# Knit Syndicate

# Observations

Lift core column detail in column schedule.

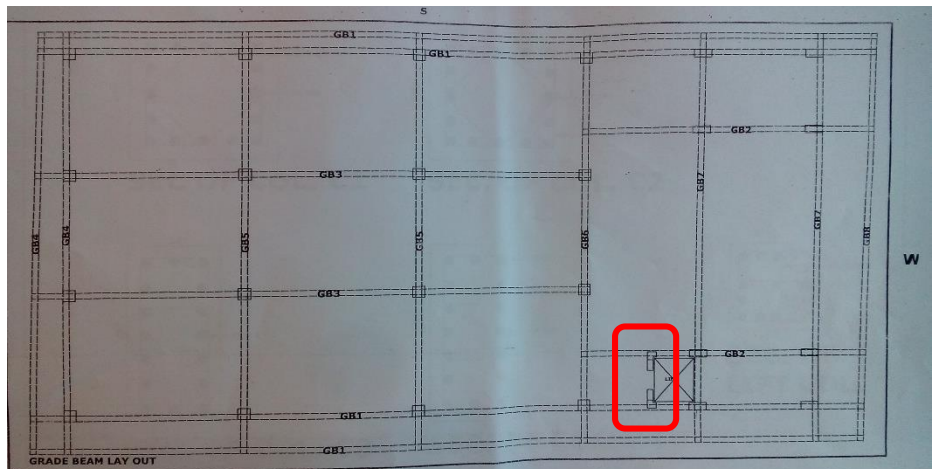
Lift core columns are appeared in grade beam layout but not exist in foundation layout. Lift core columns was suspected to be supported on mid portion of grade beam. But no connection detail was found in structural drawings. Factory engineer needs to check the adequacy of Grade beam for the concentrated load from lift core columns.

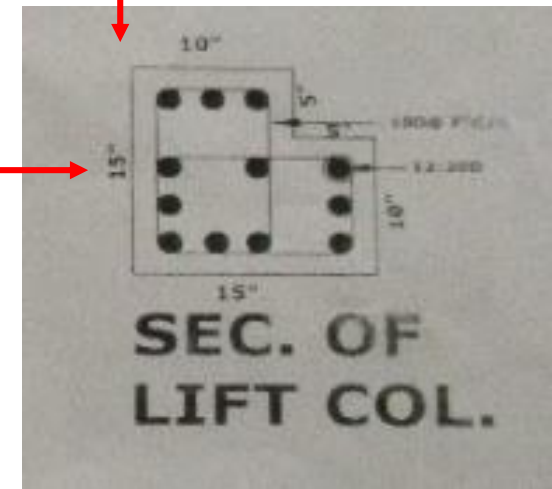
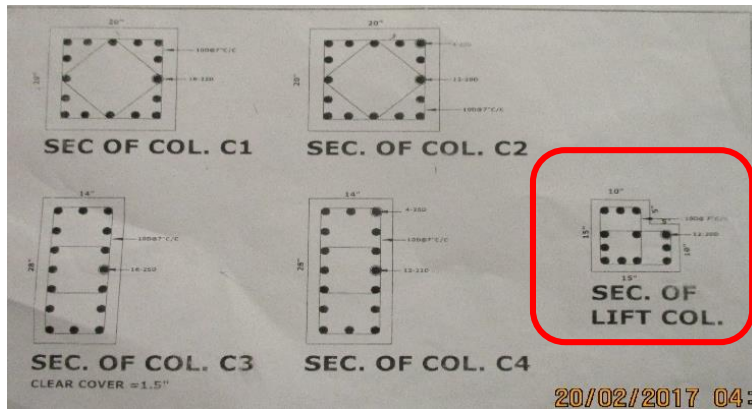
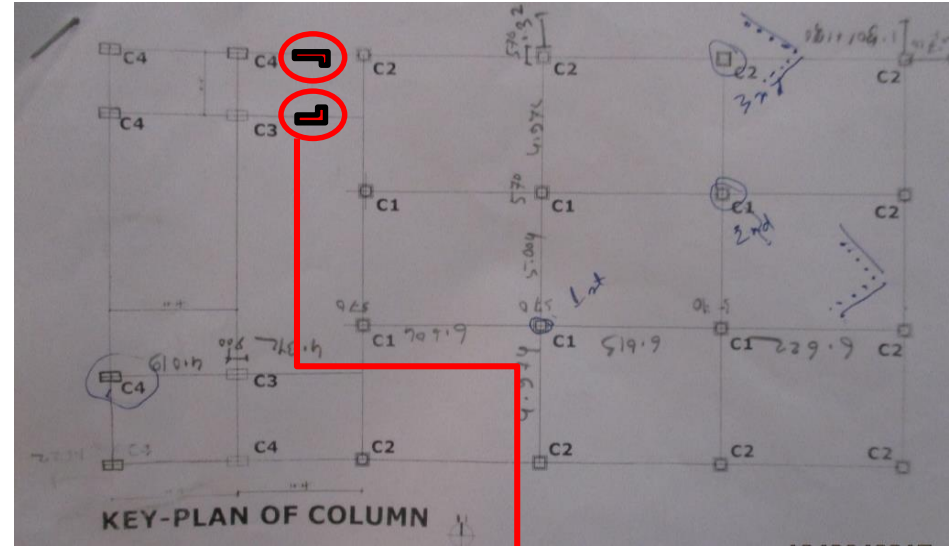
Lift column were shown in the column schedule but not on the column or foundation layout plan. Factory engineer to update the as-built drawings.

6	Discrepancies on the as-built Drawings	Building Engineer to produce a set of as built structural drawing as per as-built condition.	6-weeks
7	Hairline crack observed on beam & slab soffits	Building engineer is required to investigate the extend of cracks.	6-weeks
8	Hairline crack observed on beam & slab soffits	Carry out remedial works if required.	6-months

Beam layout

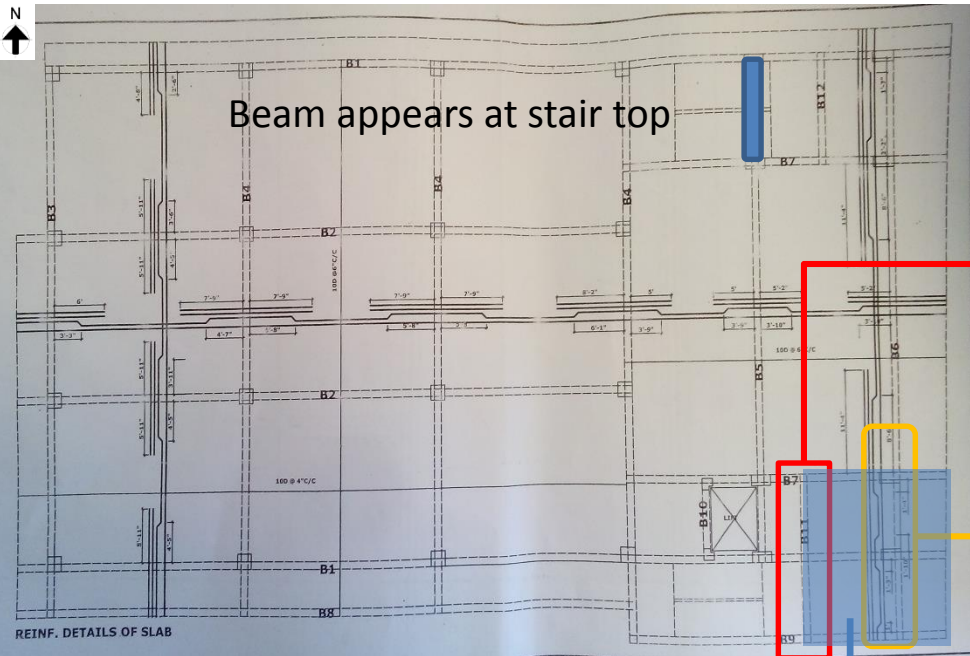
Undocumented mezzanine floor was found at ground floor. Discrepancies in beam size was found at roof.
